ALTERATION TO A HISTORIC PROPERTY STAFF REPORT

Site: 140 Highland Avenue c. 1890 – Barnes-Luce House

Case: HPC 2013.095 Single Building LHD, NRIND, NRMRA

Legal Notice: Remove chimney on west side

140 Highland Avenue, 1898

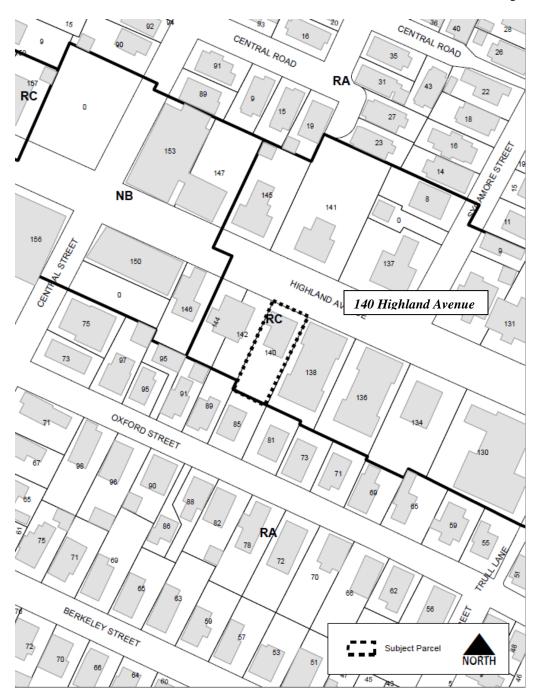
Chimneys are a major element in the visual cues of the history and use of a building. The elaboration or simplicity of a chimney, where it is located tells a lot about the building and its inhabitants. The original Page 5 of 10 Date: January 7, 2014 Case #: HPC 2013.095

chimneys were both ornate, indicating that they were intended to be admired and were not merely utilitarian.

Staff determines that the alteration for which an application for a Historic Certificate has been filed is not appropriate for and compatible with the preservation and protection of the 140 Highland Avenue Local Historic District; therefore Staff recommends that the Historic Preservation Commission do not grant Michael Guigli a Certificate of Appropriateness for the removal of a prominent chimney because it does not meet the above Guidelines. However, based on precedent, a replicated chimney in lighter weight materials that match the existing in size, color and texture with appropriate structural support could receive a Certificate of Appropriateness as there would be no visible change to the Historic District. Staff recommends that the Historic Preservation Commission grant Michael Guigli a Certificate of Appropriateness to replicate the original intact chimney either with interior supports or in a lighter weight veneer to match in size, shape and texture.
